**C104**  
**COMMUNICATION**  
**COUNCIL – October 20, 2021**  
**CW (2)- Report No. 46, Item 9**

**VAUGHAN COMPREHENSIVE ZONING BY-LAW - FINAL DRAFT - 2748355 CANADA INC.,  
MOBILIO DEVELOPMENTS LTD., RP B3S HOLDINGS INC. AND RP B3N HOLDINGS INC.  
COMMENTS**

### **COMPREHENSIVE ZONING BY-LAW REVIEW - 2748355 CANADA INC. COMMENTS**

**COMPREHENSIVE ZONING BY-LAW - SECOND DRAFT - 2748355 CANADA INC.  
COMMENTS**

**Figure 1. Landmark Locations from Schedule A2 of Zoning By-law 1-88**

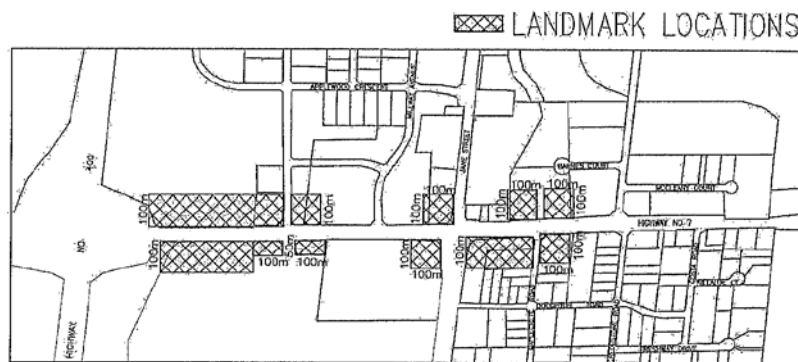
IBI Group would also like to highlight that notable provisions from Zoning By-law 1-88 are missing from the current Draft Comprehensive Zoning By-law, including the Landmark Location provision from Schedule A2 of Zoning By-law 1-88 (**Figure 1**). This provision permits unlimited height in certain locations along Highway 7 to serve as a gateway to the Highway 7 corridor. IBI Group is not supportive of the exclusion of these provisions from the Comprehensive Zoning By-law and wish to see them included in the Second Draft. Several towers have already been approved and/or constructed along Highway 7 within the Landmark Locations, setting a precedent for the built-form along this corridor. The removal of these provisions will create a disconnect between the built-form, conflicting with several of the City's Urban Design objectives and creating great variations in height and density.

**Figure 1. Landmark Locations from Schedule A2 of Zoning By-law 1-88**

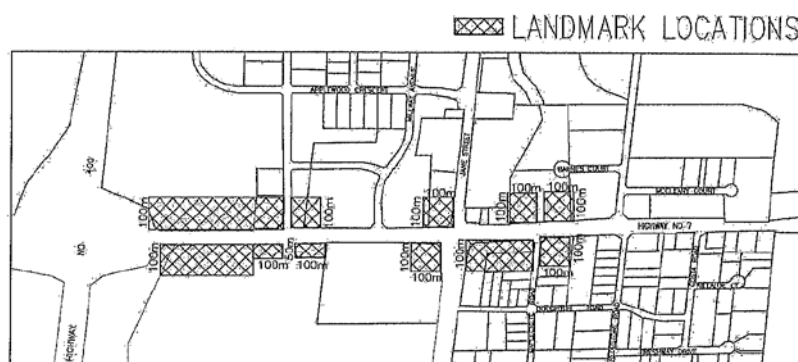
IBI Group would also like to highlight that notable provisions from Zoning By-law 1-88 are missing from the current Draft Comprehensive Zoning By-law, including the Landmark Location provision from Schedule A2 of Zoning By-law 1-88 (**Figure 1**). This provision permits unlimited height in certain locations along Highway 7 to serve as a gateway to the Highway 7 corridor. IBI Group is not supportive of the exclusion of these provisions from the Comprehensive Zoning By-law and wish to see them included in the Second Draft. Several towers have already been approved and/or constructed along Highway 7 within the Landmark Locations, setting a precedent for the built-form along this corridor. The removal of these provisions will create a disconnect between the built-form, conflicting with several of the City's Urban Design objectives and creating great variations in height and density.
